CONVAIR

COMMERCIAL CHANGE PROPOSAL

SPEC NO.: ZD- 22-324

MODEL: 22-21(#3) (Convair "880")

GENERAL ARRANGEMENT

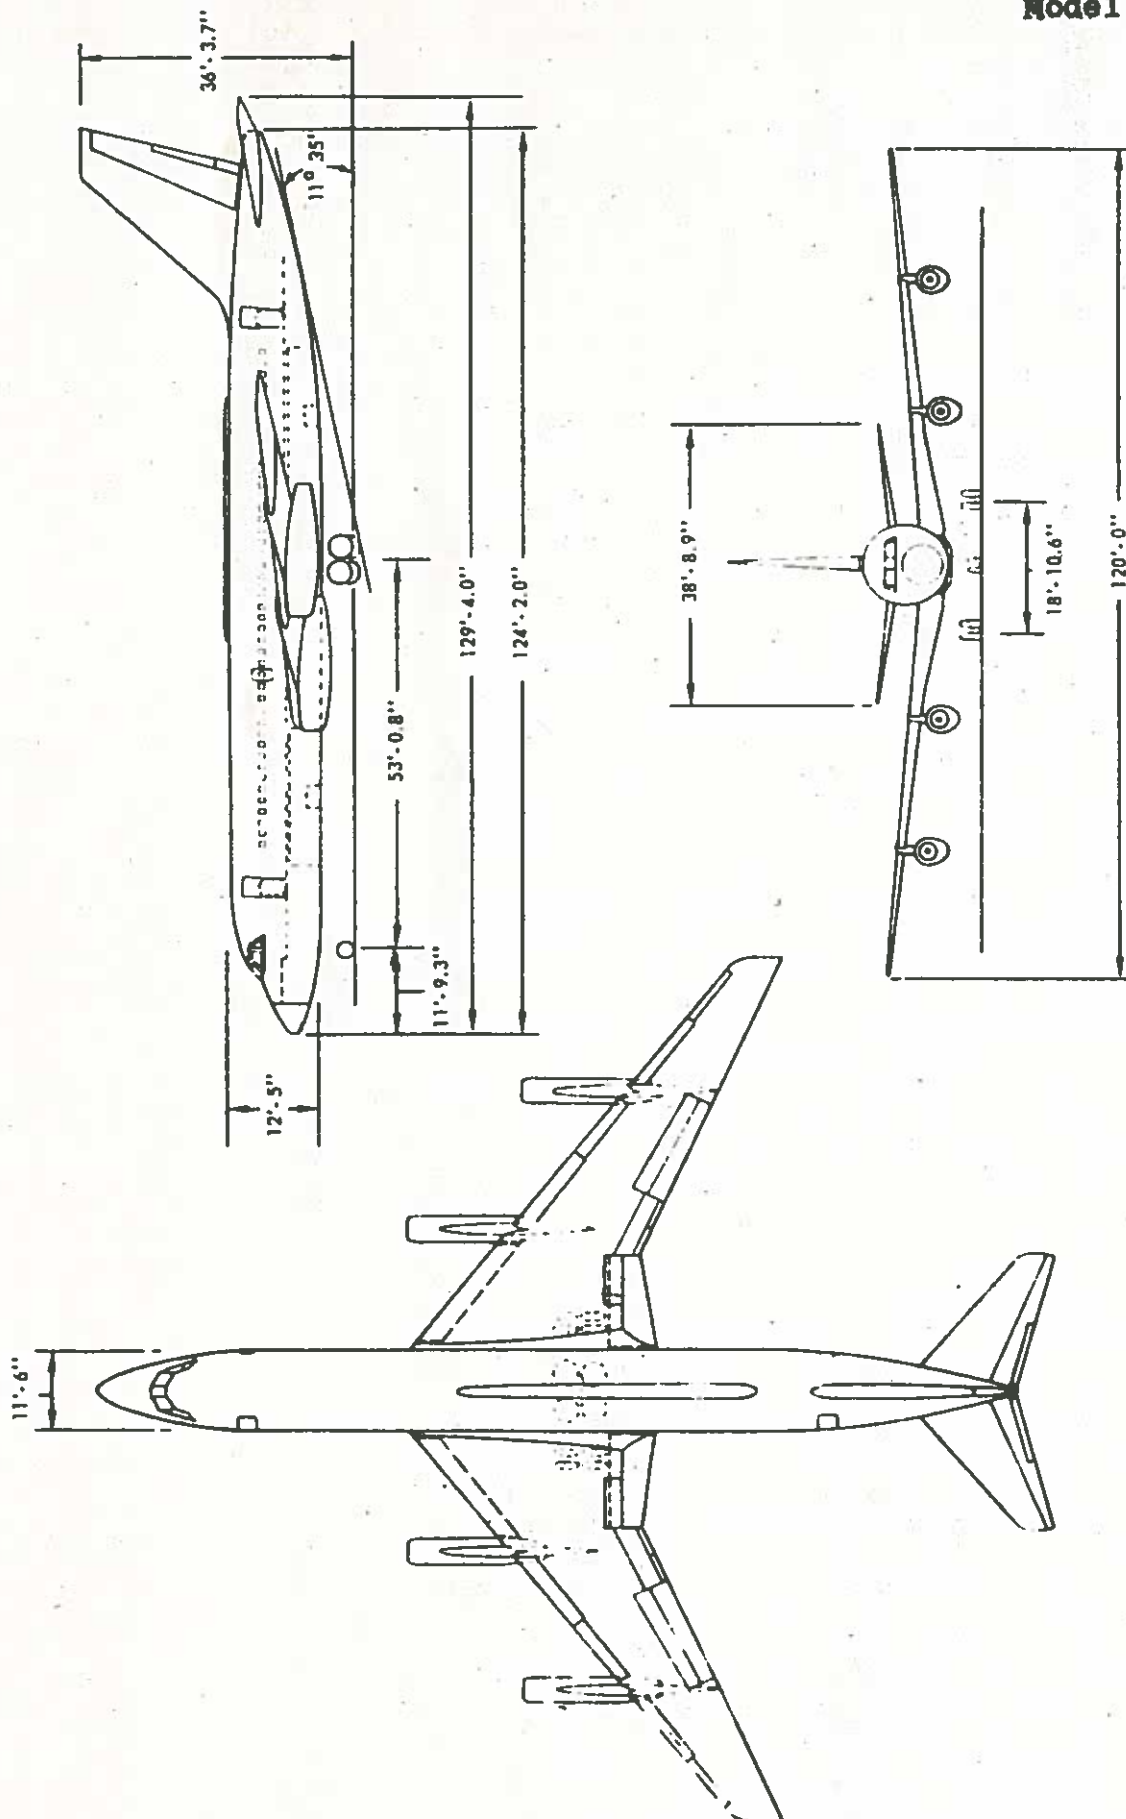
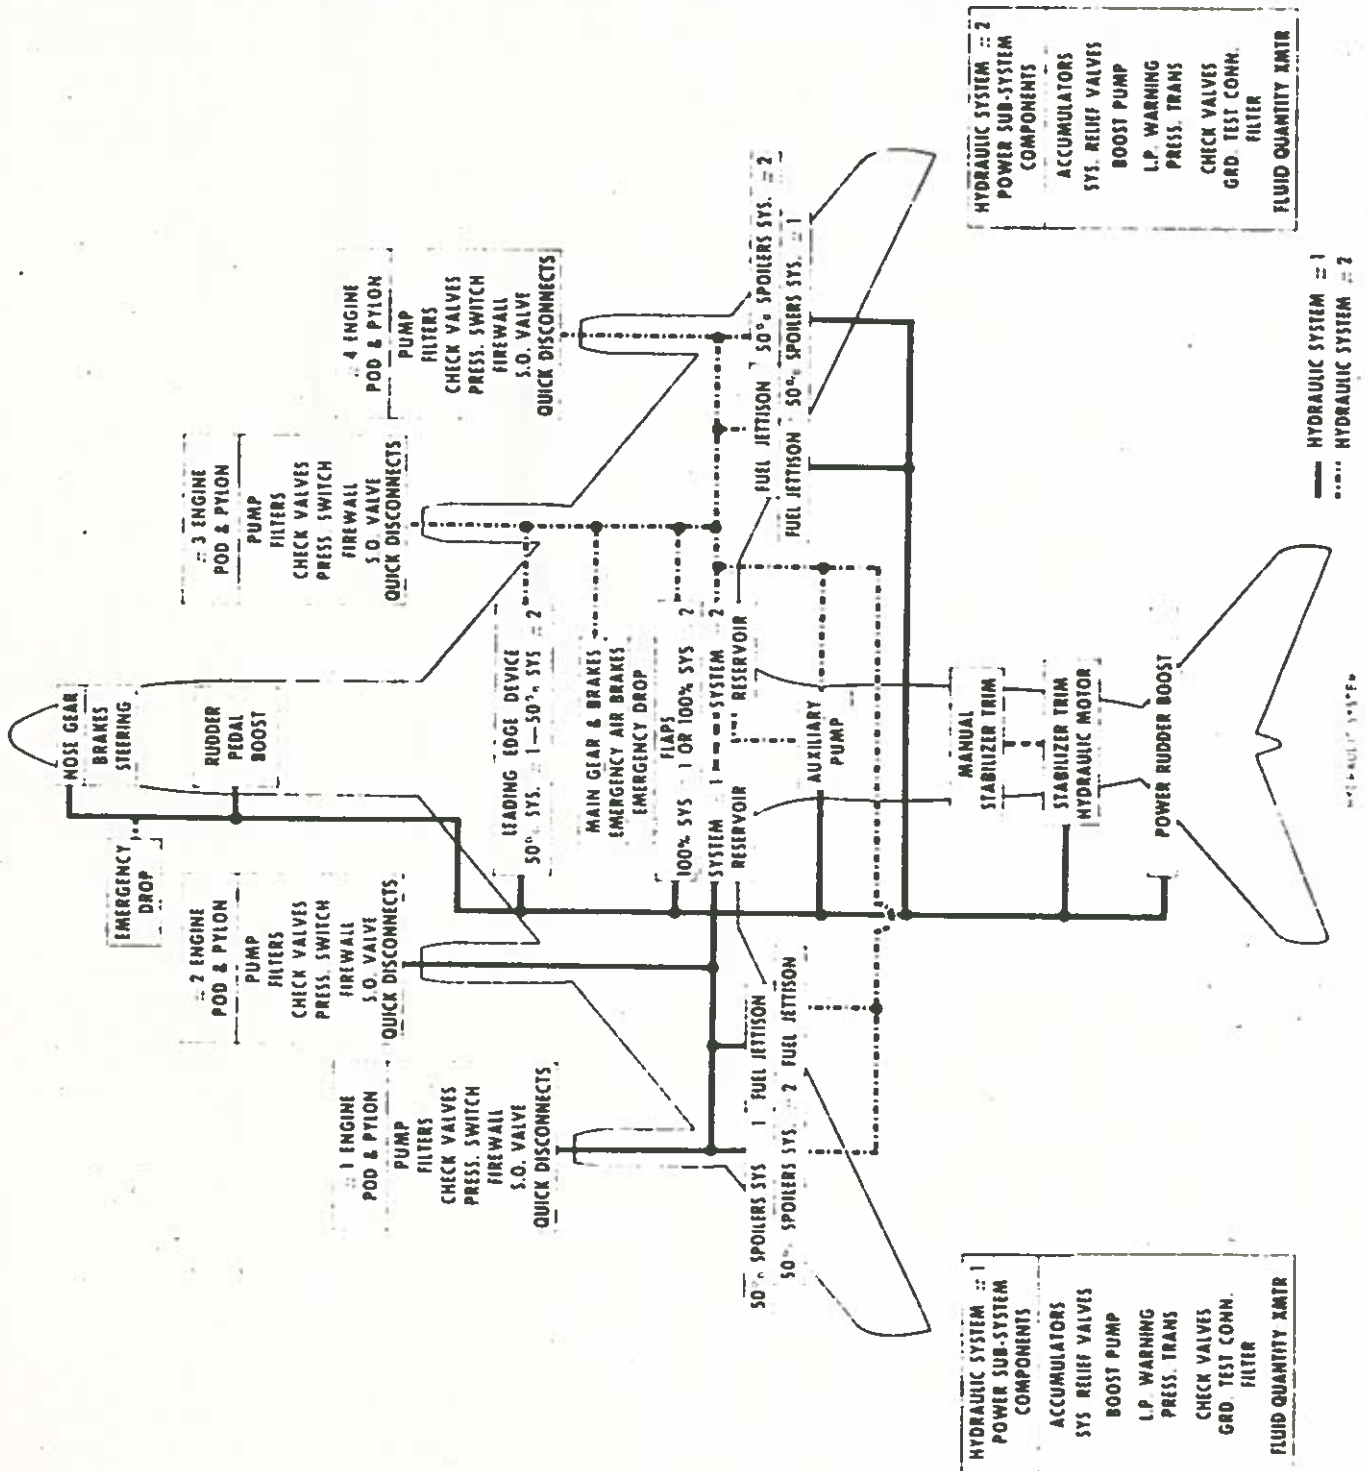
Page 3a, GENERAL ARRANGEMENT:

Replace above illustration in the specification with Enclosure (A) which shows Krueger Flap installation between inboard pylon and fuselage, and trailing edge inboard flap extension.

Enclosure: (A) One copy Page 3a - GENERAL ARRANGEMENT (Revised)

INTERIOR ARRANGEMENT
40 FIRST CLASS PASSENGERS
FAA

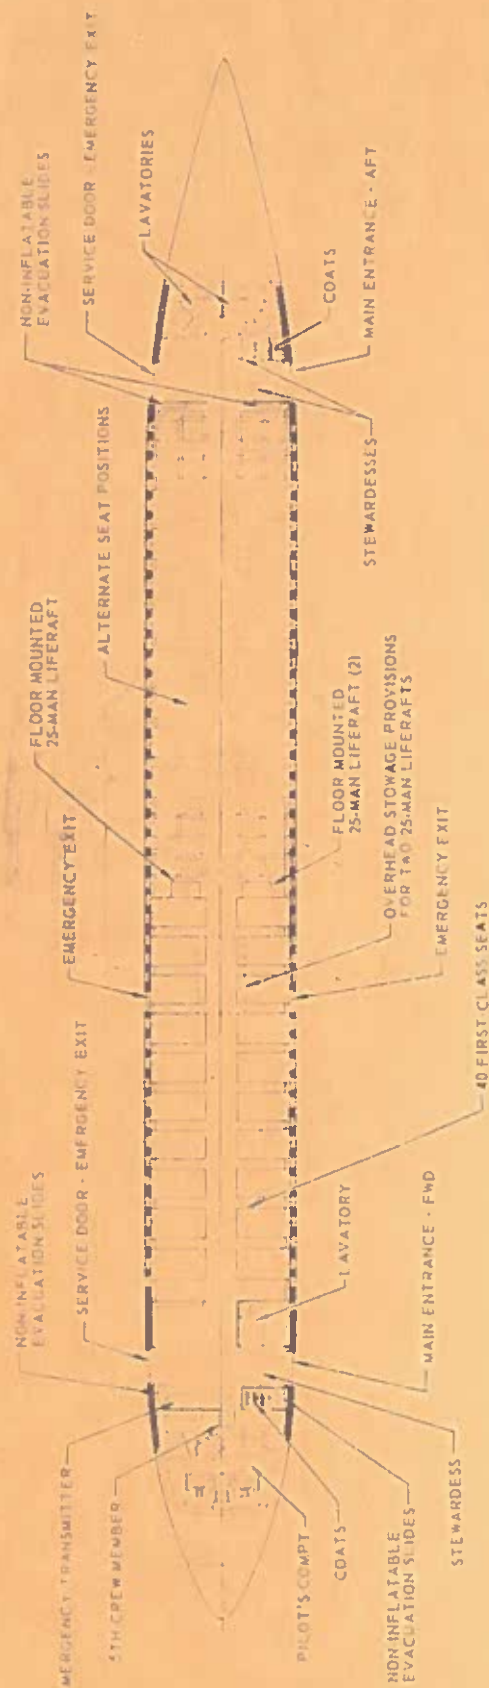
Page 3b, INTERIOR ARRANGEMENT:

Replace the above illustration with Enclosure (A) which shows the effects of this proposal.

Enclosure: (A) One copy Page 3b - INTERIOR ARRANGEMENT (Revised)
